Appln. No. 10/654,956  
Amdt. dated November 30, 2006  
Reply to Office action of October 6, 2006

**Amendments to the drawings:**

**REMARKS / ARGUMENTS**

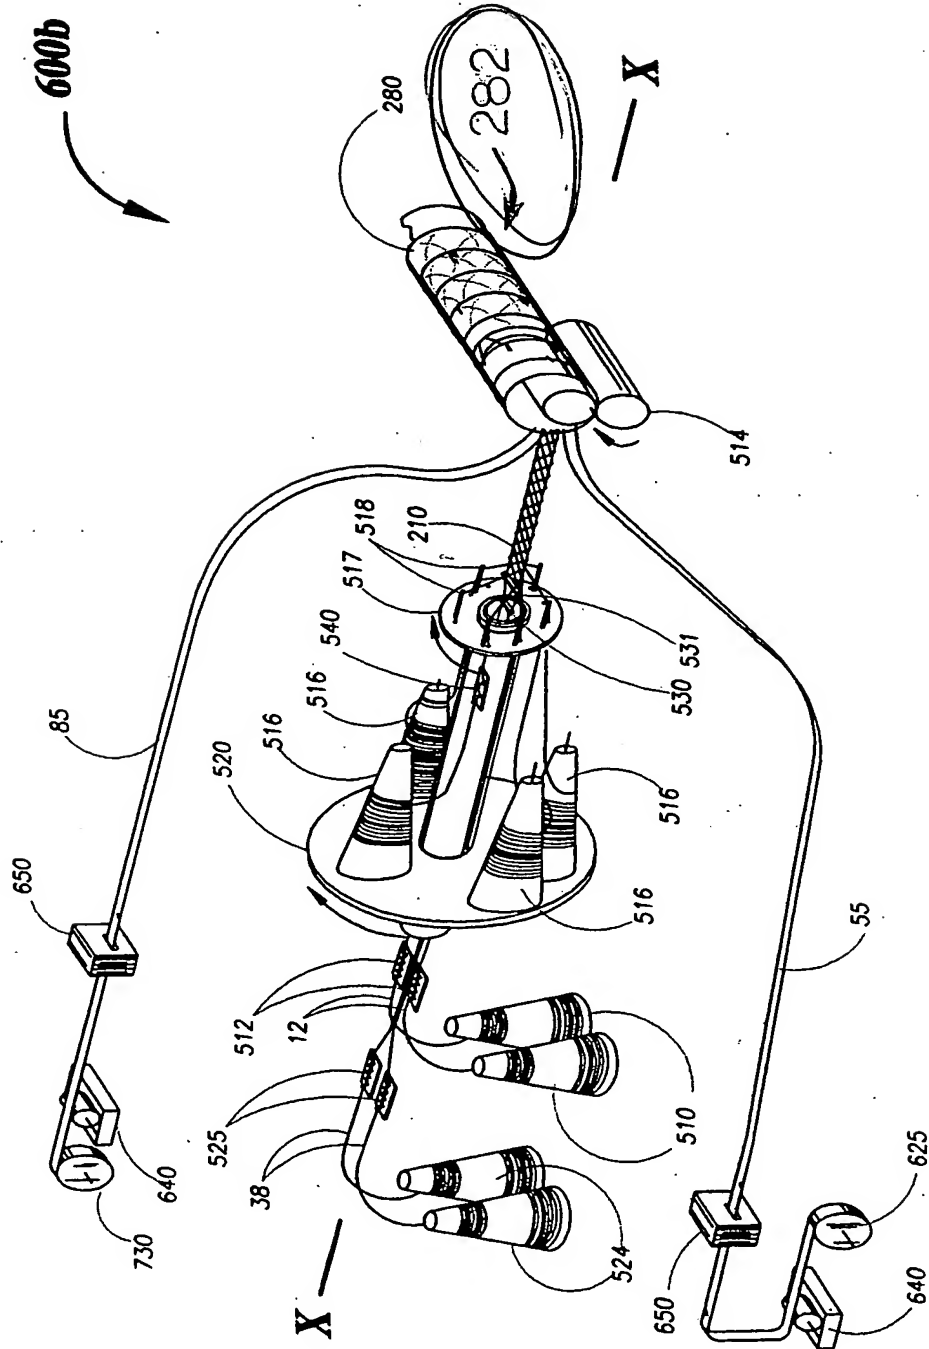
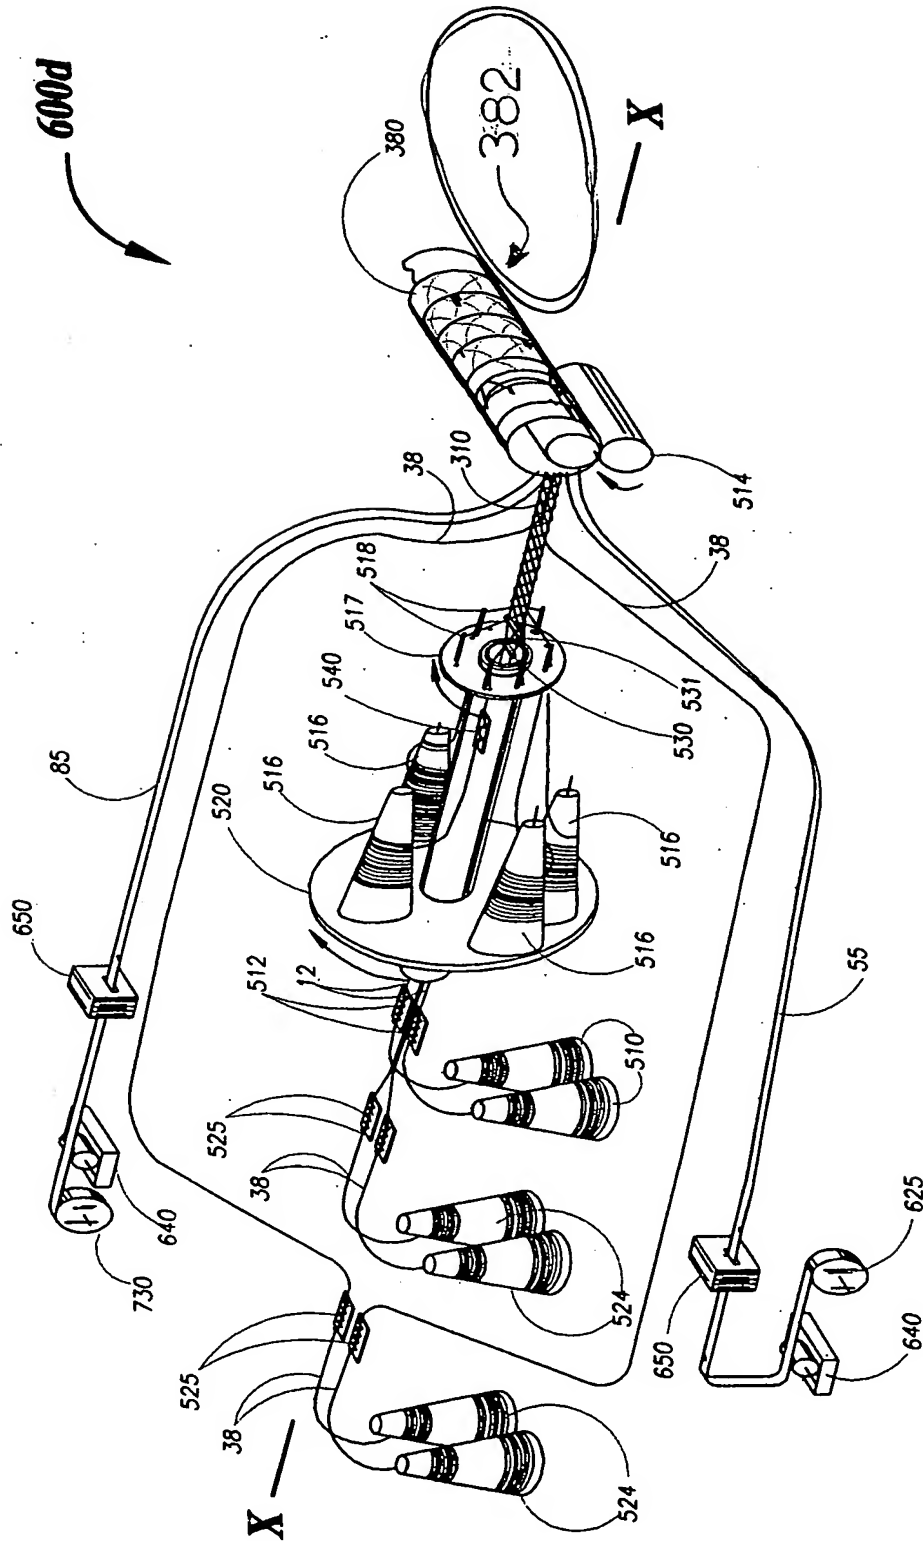
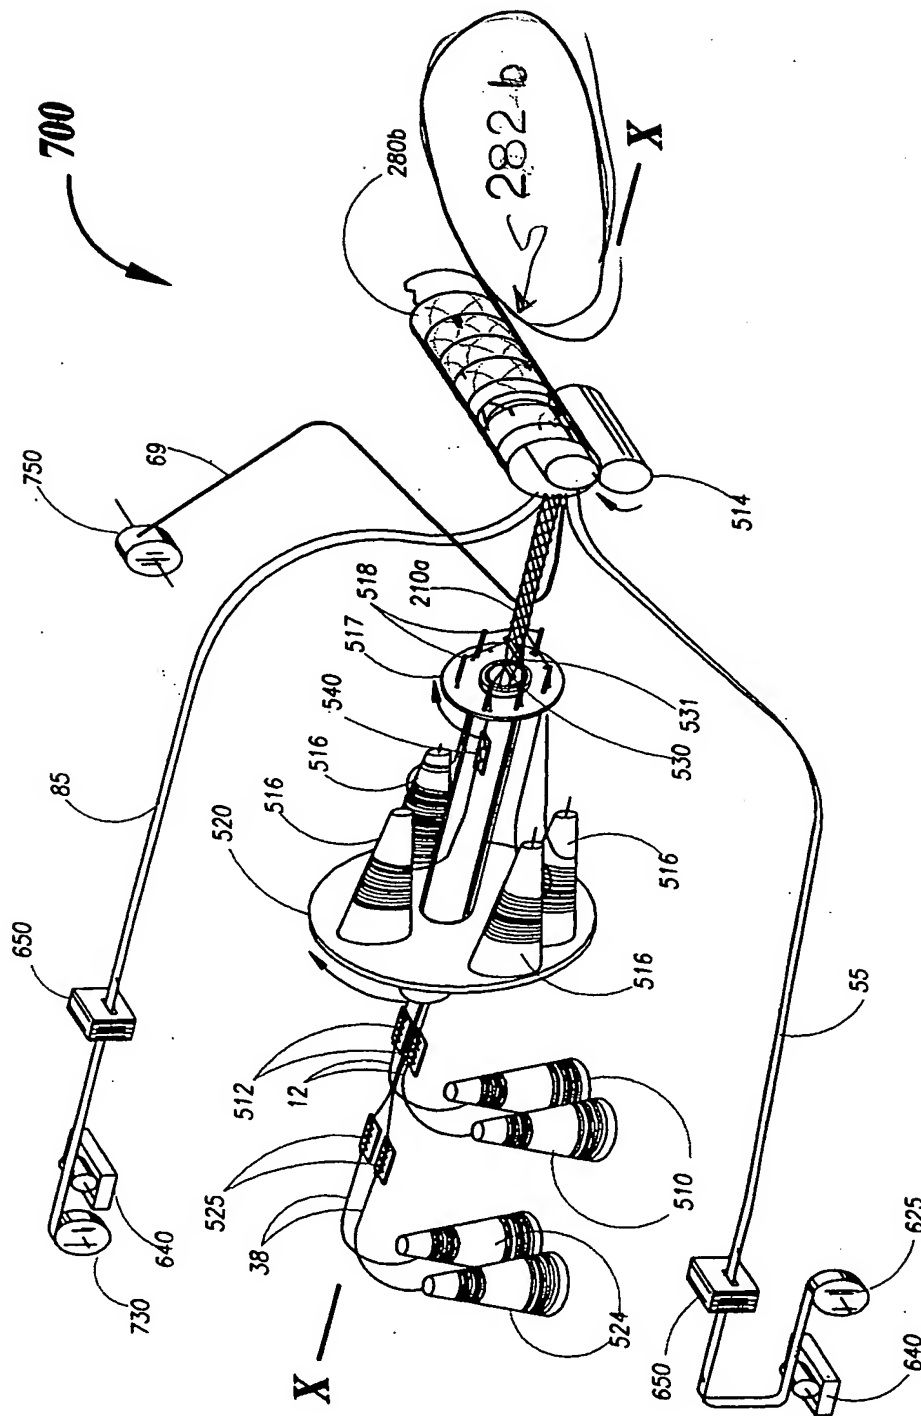
The attached sheets of drawings includes changes to Fig. 15b, 15d, 16 and 16a. These sheets, which includes Fig. 15b, 15d, 16 and 16a, replace the original sheets including Fig. 15b, 15d, 16 and 16a.

Inasmuch as the discussion involved the word "conduit" and how it was referred to in the specification, the applicant also desires to amend the application to include reference numbers specifically identifying the conduit as discussed in the specification and as shown in the drawings, all as filed. Accordingly, we enclose revised paragraphs 102, 104, 105, 106, 107, 109 and 110, to more clearly identify the laminate by reference to numeral 280, 280b, 380b and 300. We also enclose revised figure 15b in which the numeral 282 has been added to the conduit illustrated therein, figure 15d to which the numeral 382 has been added to the conduit illustrated therein, figure 16 to which the numeral 282b has been added to the conduit illustrated therein and figure 16a to which the numeral 382b has been added to the conduit illustrated therein. In each case this is assigning a numeral to the conduit as shown in the drawings and as described in the specification, all as originally filed. Thus, no new material is involved in these changes.
